INDESIT company

Model type:
LBE88ALL/HA

Commercial code:
F051794

n1040282: New drainage OKO system.

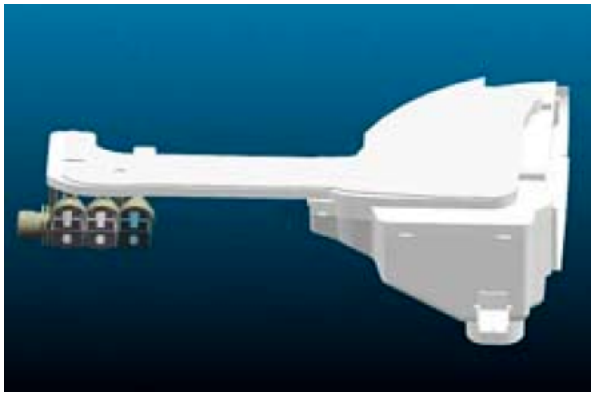
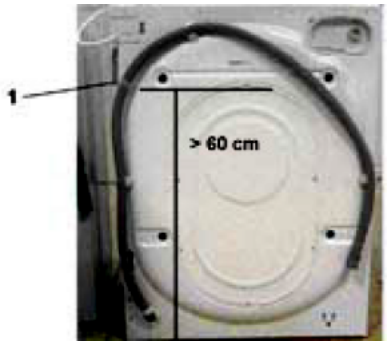
From serial number 21219.0001, the new "OKO" drainage system has been introduced on the washing machines produced in the Comunanza factory.
The last two numbers of the Industrial Code (located on the rating plate) of the models relevant to this note will be 30 (e.g. 80233560130 - see Appendix A)

The new items are:

- EEPROM (the OKO system requires a new setting of load timing parameters). THE NEW EEPROMS REPLACE ALL THE ONES CODED PREVIOUSLY.
- BOWL (hopper tube hole shifted forwards);
- DETERGENT LOADING TUBE (see fig. 1);
- PRESSURE SWITCH (changed levels);
- OKO PUMP BOWL BLOWER + BALL (see fig. 2A, 2B and 2C);
- CONDUCTIVITY SENSOR (if provided, it is shorter than the premodification item);
- DRAIN PUMP (without detergent collecting tube connection);
- HOPPER (shifted in front of detergent loading tube connection). Fig. 3A post-modification. Fig. 3B premodification);
- AIR TRAP (different shape);
- PRESSURE SWITCH TUBE (different length);
- DRAIN TUBE STOP (specific);

In particular, the OKO system consists of a spherical plastic component inserted in the tube that connects the bowl to the drain pump (see fig.2 A).
At the beginning of each wash cycle the washing machine fills water for 10 seconds and activates the drain pump for 2 seconds. In this way, the water level in the bowl is different from that in the drain tube; this difference increases the thrust of the ball upwards, closing the bowl-pump connection tube hermetically (see fig. 2D).
This system has the double advantage of:

1) separating the wash water and the water in the drain hose, thus saving energy during the heating phase;
2) and ensuring optimal use of all the detergent.
With the introduction of this new component, the detergent collecting tube is no longer required and the pump has one hole only to convey water from the tank.
For the correct operation of the OKO system, it is important that the drain hose of the washing machine remains fixed to the back of the unit with a plastic clamp (to this end, the clamp withstands a 25 kg load; see reference 1 in fig. 4); otherwise, the drain hose must absolutely reach the height of the clamp. (minimum 60 cm.)
